INTERCONNECTION AGREEMENT

High Lonesome Wind Power, LLC

July 22, 2019

FIRST AMENDMENT TO INTERCONNECTION AGREEMENT

Exhibit "C3"
Substation Location – TSP Interconnection Facilities

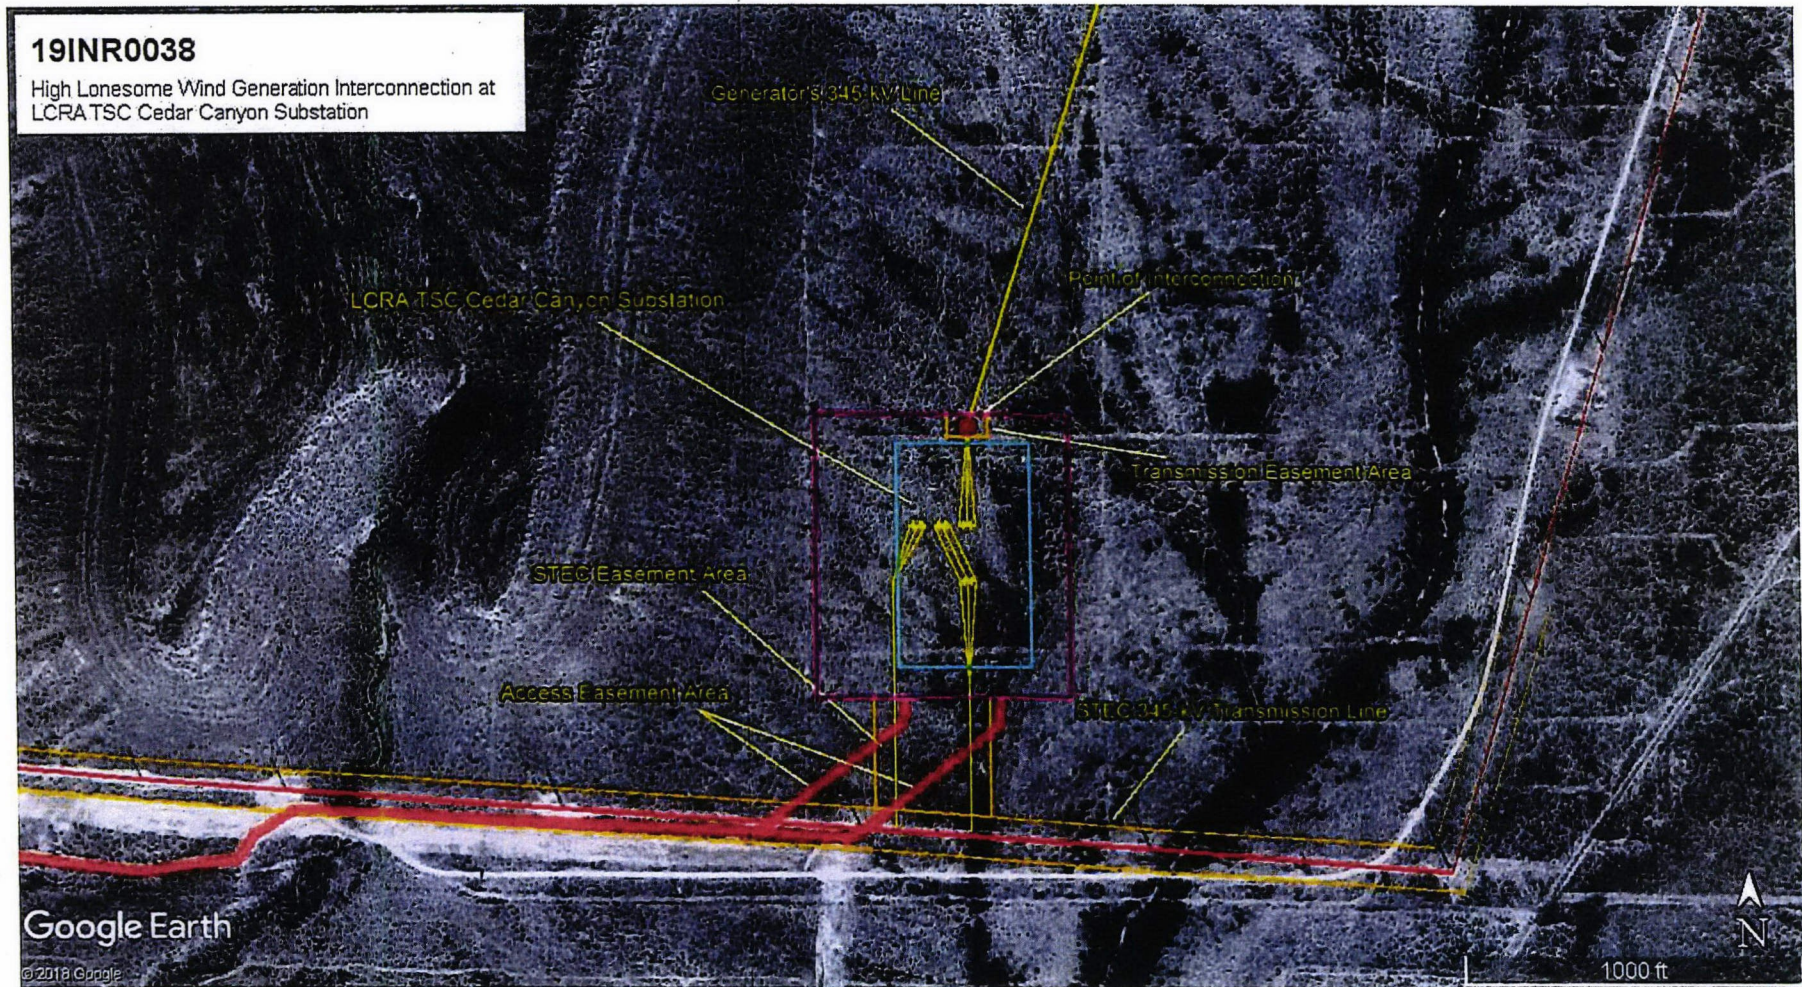
WHEREAS, Generator has requested that TSP relocate the proposed Transmission Interconnection Facilities including the TSP's proposed Cedar Canyon Substation;

1. Exhibits "B", "C", "C2", "C3" and "D" are deleted in their entirety and the Exhibits "B", "C", "C2", "C3" and "D" attached to this Amendment are hereby added to the Agreement in lieu thereof.
2. This Amendment will become effective upon execution by the Parties.

(b) Generator has also conveyed to TSP access easements that provide good and adequate rights of vehicular ingress and egress to and from a public road and are generally depicted as the "Access Easement Area" in Exhibit "C3".

(c) In addition, Generator shall acquire easements for STEC (in a form acceptable to STEC) that connect the Substation Site to the existing STEC transmission line easement and for access rights for necessary overhead and underground utility services and communication services to the Substation Site generally depicted as "STEC Easement Area" in Exhibit "C3".
